Selected pages from the Design report (pages 34 & 35) and from the Arboricultural report (Appendix TMP01)

SEPP(HOUSING) SCHEDULE 9 DESIGN PRINCIPLES **PRINCIPLE 5** LANDSCAPE BY 360 DEGREES

EXISTING LANDSCAPE AREA

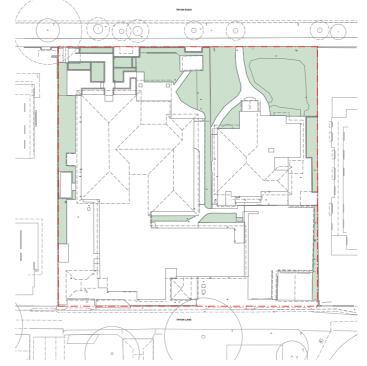
Page 34 "Existing Landscaped area" shows foliage (green) along the western side of the site to within about 20m of Tryon Lane. This area is where the cupressus and the palm tree are, very close to the fence.

PROPOSED LANDSCAPE AREA

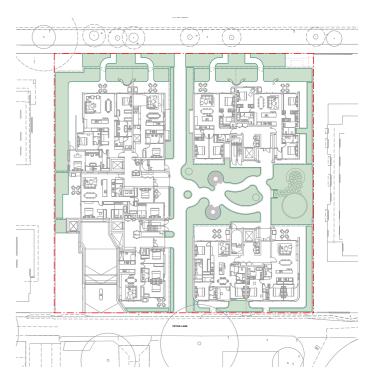
Page 34 "Proposed Landscaped area" also shows foliage along the western side of the site, but ending at the lift in the driveway area. That is just where the fine Cupressus is at present. This tall tree with a fine canopy is classified by the arborist as "High A1, worthy of being a constraint". It is very close to the boundary fence (one metre from it) and not close to the new building. It could be preserved with appropriate protection during construction and enhance this part of the site where there is not landscaping.

The Canary Island Palm is located also close to the fence but about 4m further towards Tryon Lane. It is not very high (9 metres) and although not clssified by the arborist as significant, could also be preserved to enhance the area.
